From:	
To: Sent:	3/31/2021 10:19:03 AM
Subject: Importance: Attachments:	FW: PM Sneath Lane 1107 High FW: PM Sneath Lane 1107 ; FW: Projects approved by WFGC 3.24.20

From:		
Sent: Wednesday, Ma	rch 31, 2021 9:02 AM	
To:		
Cc:		
Subject: RE: PM	- Snea <u>t</u> h Lane 1107	
Good morning	H

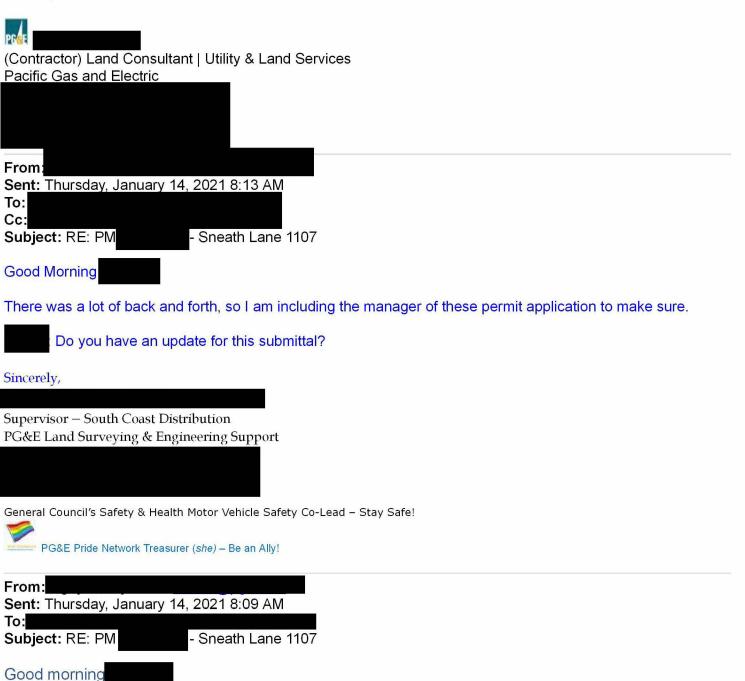
Did you want 17 dimensioned even if it's not in Caltrans RW? There's not a lot of space with the other dimensioning.

Thanks for checking in the field. After updates the map for both locations 17 & 18; I believe the only one that might change would be 17 as I am not seeing the distances for that location on the base map.

: In both locations 17 & 18 the anchors are going away from the ETW in a more of less perpendicular direction. Therefore, please add these anchors to both locations 17 & 18. As you already labeled loc. 18 pole, you just need to add the 10ft dimension for the anchor. You will still need to fully dimension location 17. i.e.

Anchor-Pole-ROW-ETW-C/L; if you get my drift.

I was able to look at the anchors in the field but was unable to measure it. Location 18 is on private property that I could not access and Loc 17 was on a very steep hill side that I could get to. However, look at the anchor leads in the field I still believe that 10' lead is correct.
